Technical Comments on Electric Generating Unit Control Technology Options and
Emission Allocations Proposed by the Environmental Protection Agency
in Support of
the Proposed 2015 Ozone NAAQS Transport Rule

Midwest Ozone Group
National Rural Electric Cooperative Association
American Public Power Association

June 17, 2022

Figure 7-4. Count of Units Emitting Above Proposed Backstop Rate

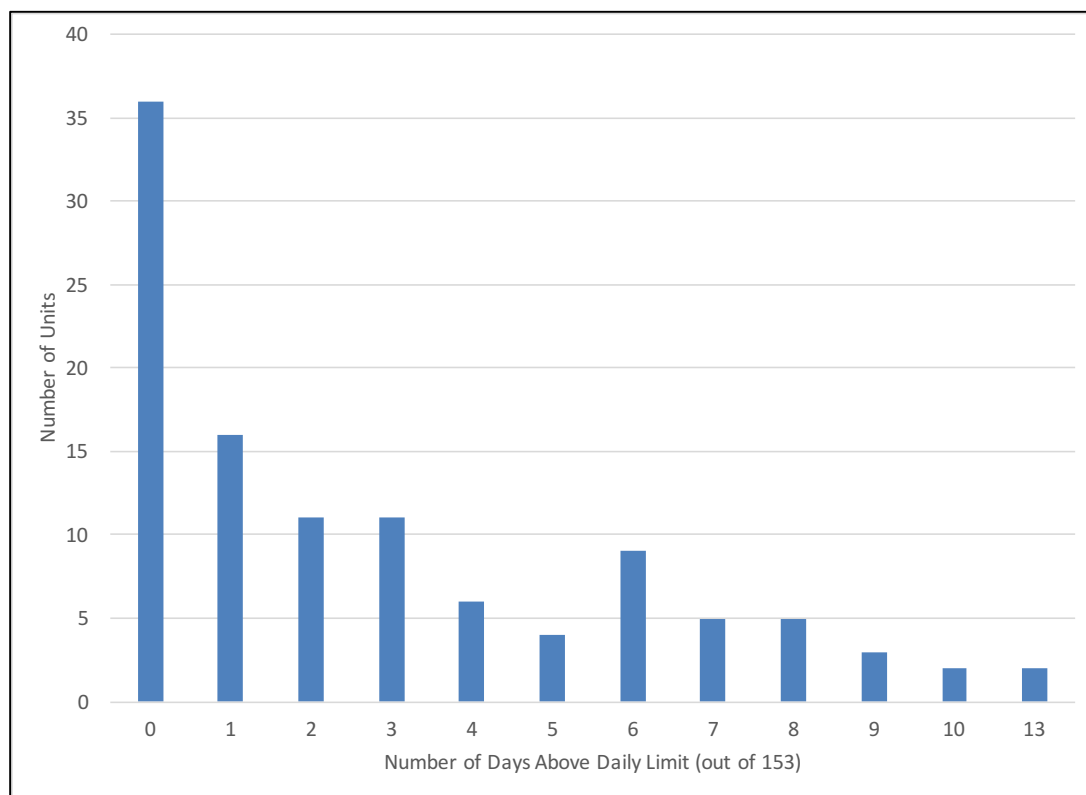
Count of Units with Daily Emissions Above the Proposed Backstop Rate. Figure 7-4 reports for the 110 units that achieved 80% NO_x reduction for the 2021 ozone season, the number of units for which NO_x is observed to exceed the proposed daily rate of 0.14 lbs/MBtu. Figure 7-4 shows about 1/3 of the total units in this population – 36 – do not experience excursions in NO_x daily rate exceeding the proposed 0.14 lbs/MBtu. The horizontal axis describes the increase in units that emit more than 0.14 lbs/MBtu, for multiple days. For example, eleven units operated above 0.14 lbs/MBtu for three days, while five units exceed that rate for 7 days.

Figure 7-7. Role of Days Following Startup on Days Exceeding Daily Rate

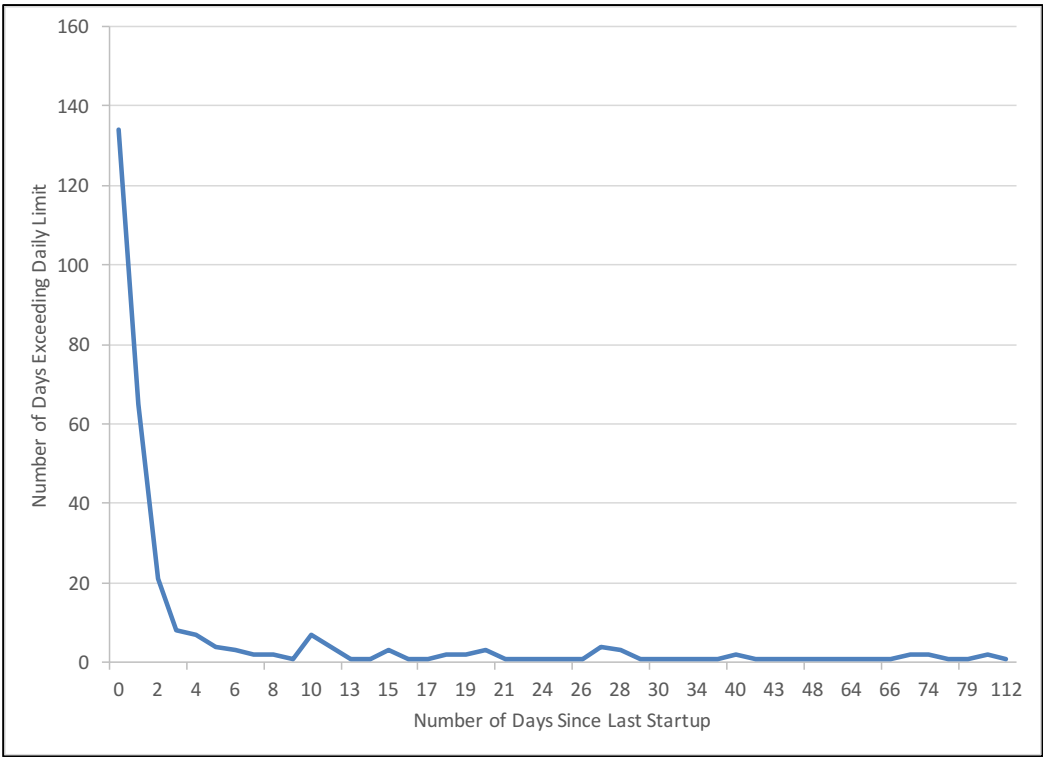
Role of Days Following Startup. The operating time subsequent to a startup is one indicator potential for daily rate exceedances. Figure 7-7 presents data derived from the inventory of units operating over the 153 day 2021 ozone season, describing the number of days that exceed the proposed daily backstop rate.

Figure 7-7 shows operating within 1 full day of startup, a total of 65 observed days were recorded with NO_x exceeding the 0.14 lbs/MBtu rate. But within a second day the observed days exceeding 0.15 was dropped by 1/3, to 21 total days. After 4 days such observations are negligible.

Figure 7-8. Role of Load Factor

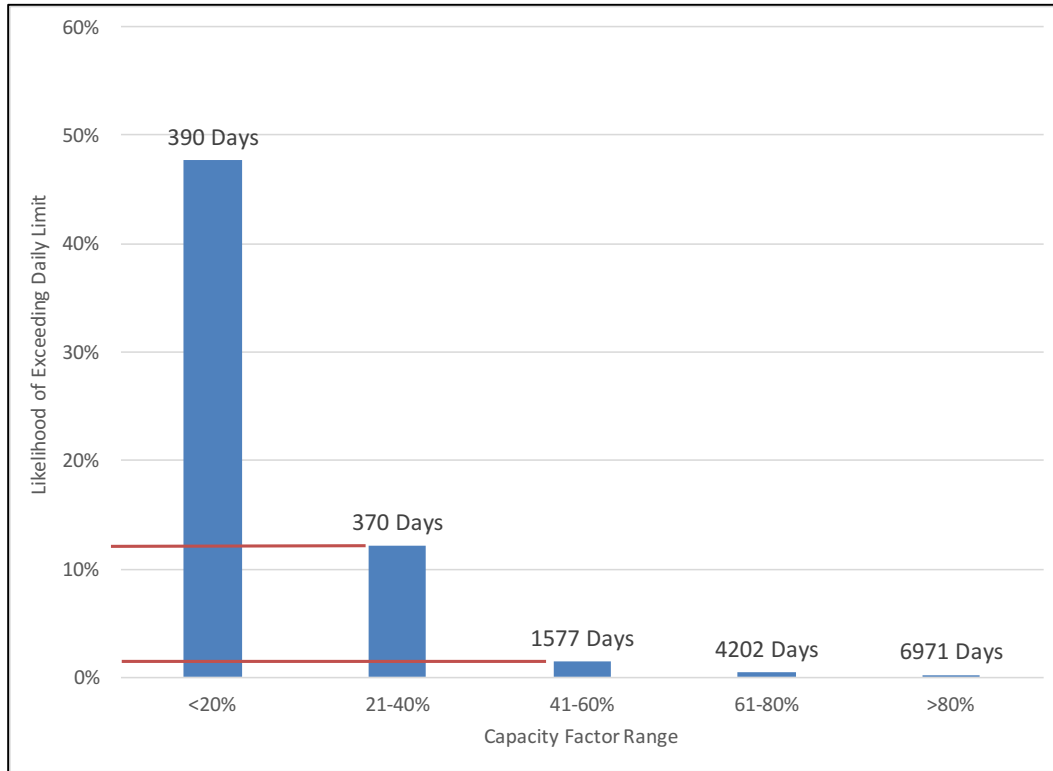
Figure 7-8 reports the cumulative number of days that all units in the 110-unit study population exceeded the proposed backstop rate of 0.14 lbs/MBtu for the 2021 ozone season. The left axis reflects the fraction of total operating days in each load “bin” that exceeded the proposed backstop rate. For example, over the 2021 ozone season, units operating at or below the 20% load “bin” recorded a total of 390 days exceeding the proposed backstop rate – equal to 47% of operating days in that load bin. A similar number of operating days – 370 – were recorded for all units operating in the 21-40% bin with NO_x exceeding the proposal backstop rate, comprising 12% of all operating days in that bin.

The combined operating time for these two low load categories – 756 days – represents conditions where SCR is not operating in an optimal state, or must be terminated as inlet gas temperature is below the minimum required for injection. At these conditions, the generating units operate with no material postcombustion control of NO_x emissions. Conversely, above 80% load, 6,971 operating days were recorded with NO_x emissions less than 0.14 lbs/MBtu.

These data show units in the select boiler population which meets the 0.08 lbs/MBtu limit, it is almost unavoidable to incur an outage and thus startup that causes a unit to emit more than 0.14 lbs/MBtu. Even altering the definition of how the rate is calculated - from a daily rate to a short-term, multi-day rate such as an average of 2 or 3 days –leaves significant number of operating events exceeding the 0.14 lbs/MBtu rate.
